**DEVIATION REVIEW
 AND DECISION FORM**

Subdivision or Project Name: Glen at Widefield Filing 8 and 9

Section of ECM from Which Deviation is Sought: D.3 Pavement Design Criteria

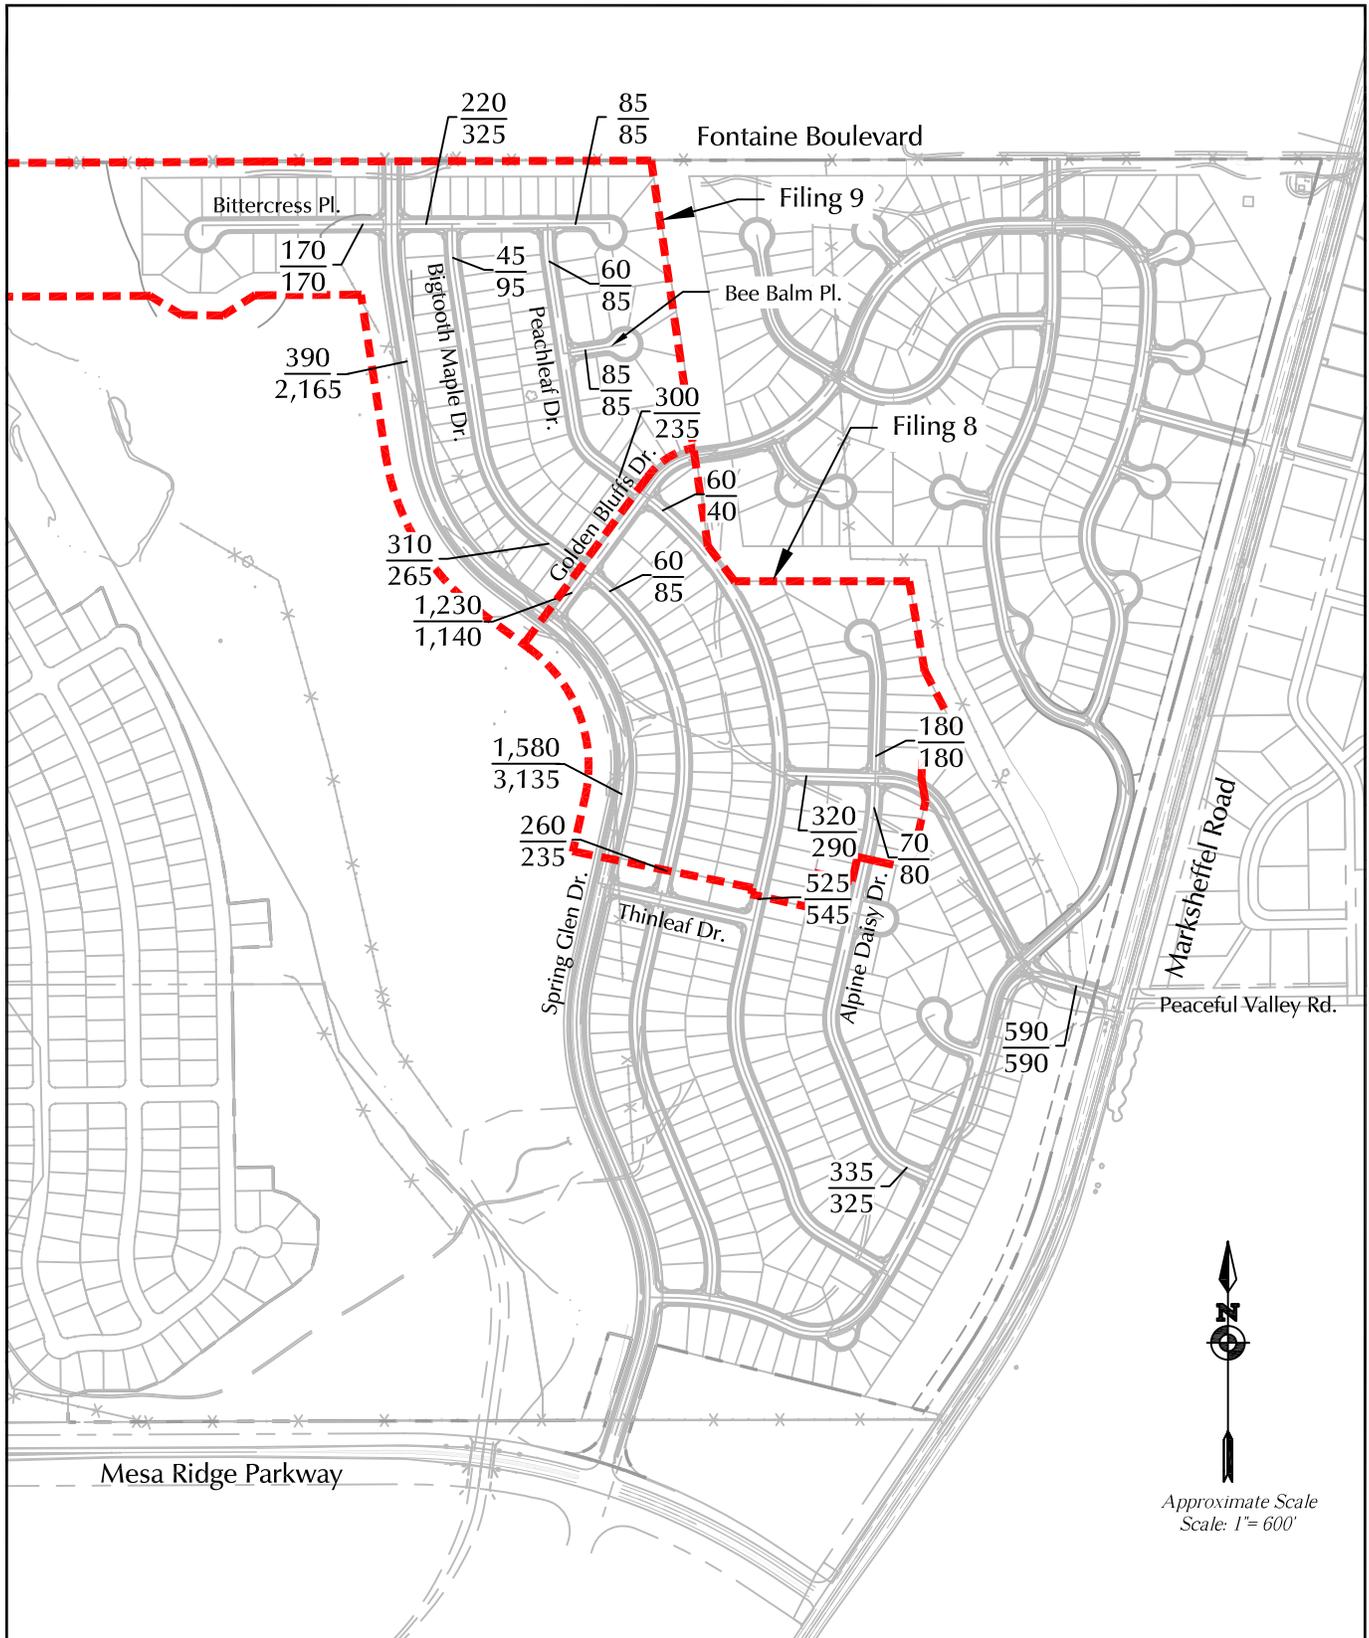
This request has been determined to have met the criteria for approval. A deviation from Section D.3 of ECM is hereby granted based on the justification provided. Comments:

The approval of this deviation is limited to filings 8 and 9 only, and shown on the attached exhibit.

Figure 1

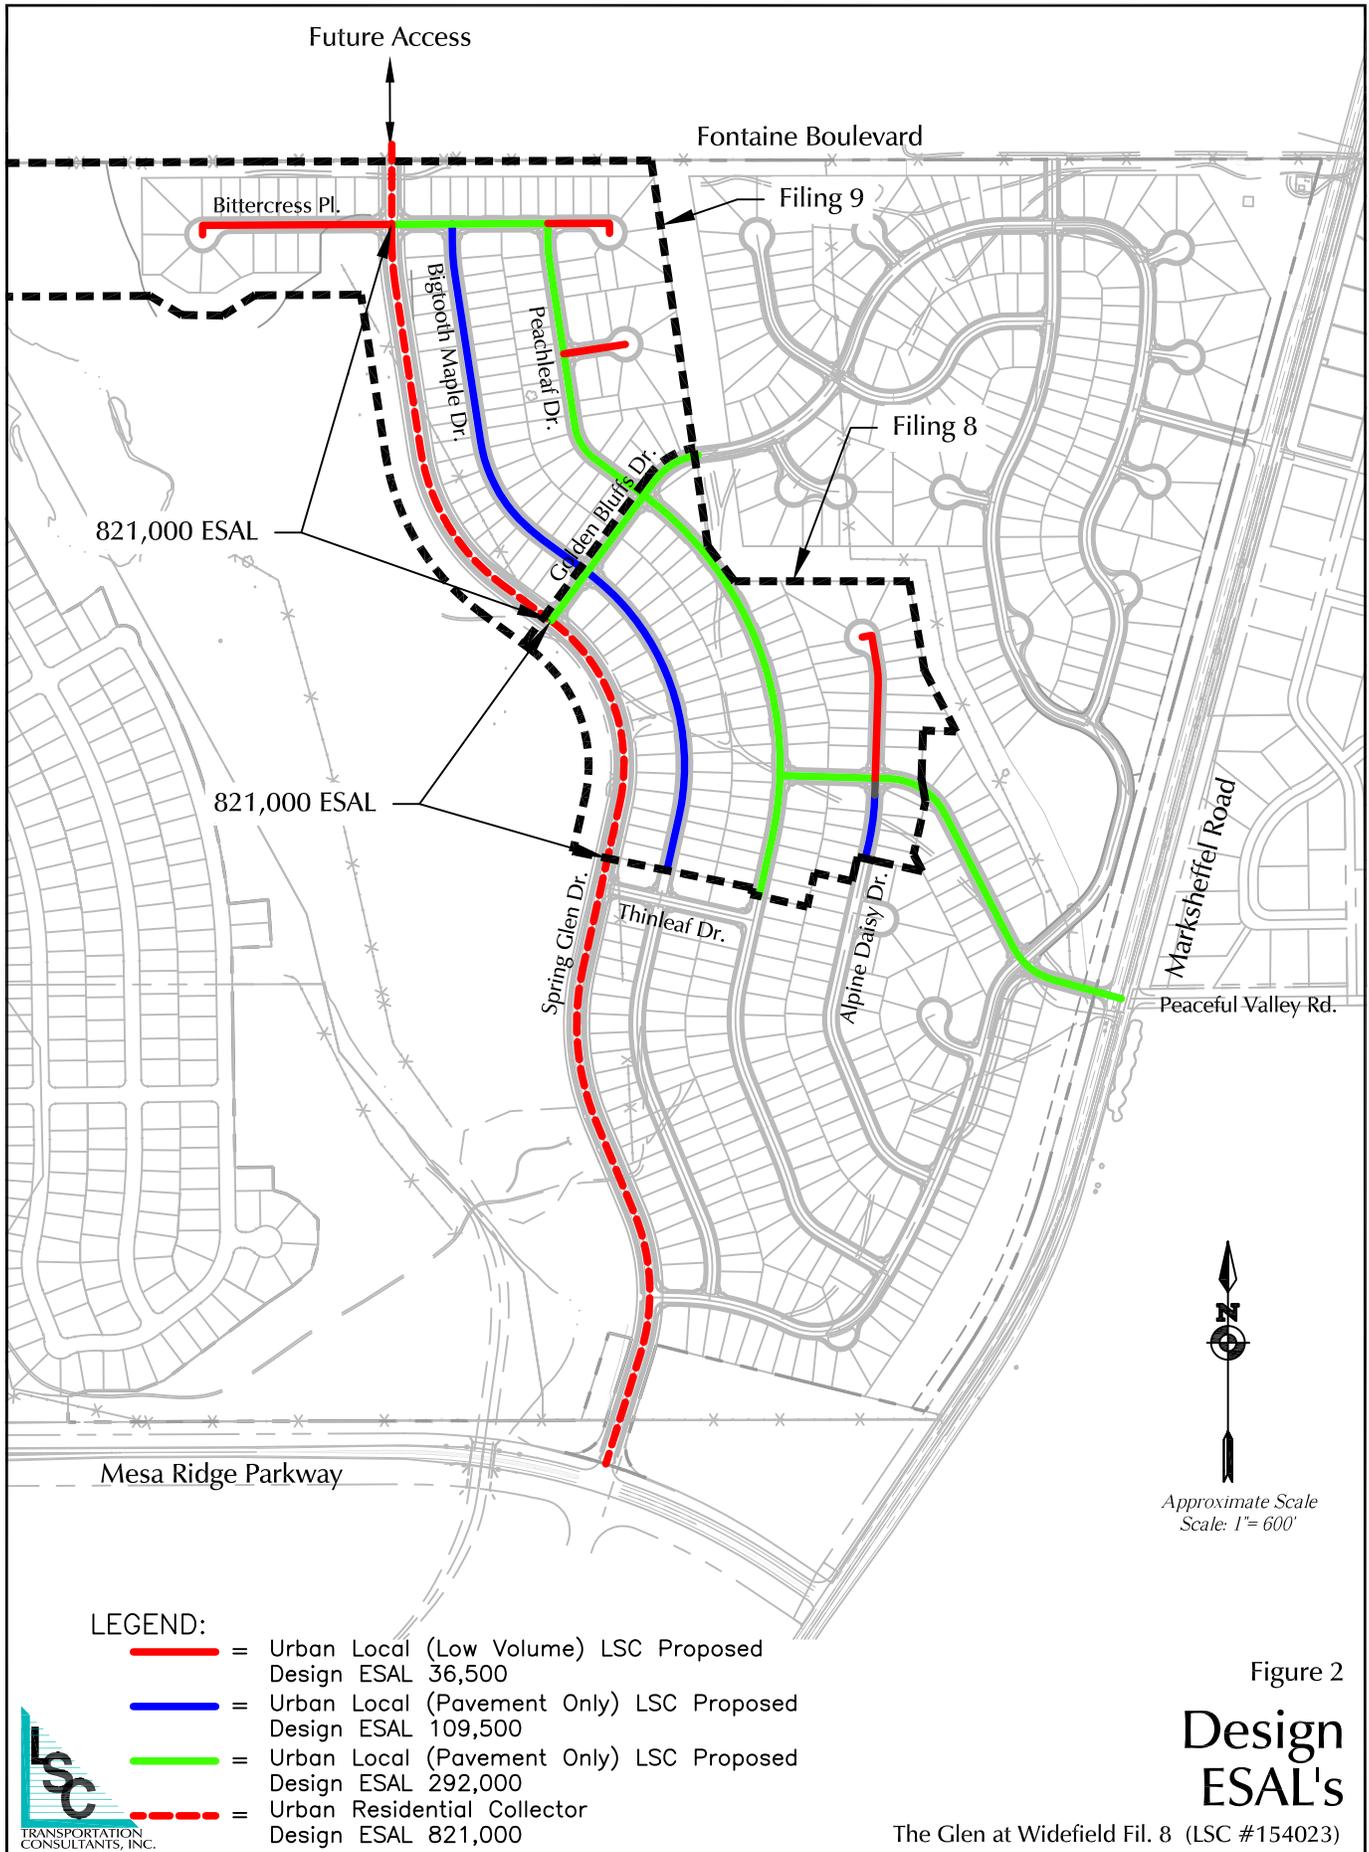
Allow use of ESAL values based on intermediate ADT ranges within the broader Urban Local ADT range (300-3,000 vehicles per day) which result in modified pavement cross sections for Bigtooth Maple Drive and Alpine Daisy Drive. The resulting recommended design ESAL for these two streets based on this methodology is 109,000 per the submitted memo dated September 20, 2018. The two exhibits from the memo showing the subdivision street names and proposed ESALs is attached.

The ECM-required design ESAL for an Urban Local street is 292,000. The proposed design ESAL for Bigtooth Maple Drive and Alpine Daisy Drive is 109,000. This is 183,000 less than the ECM minimum ESAL.
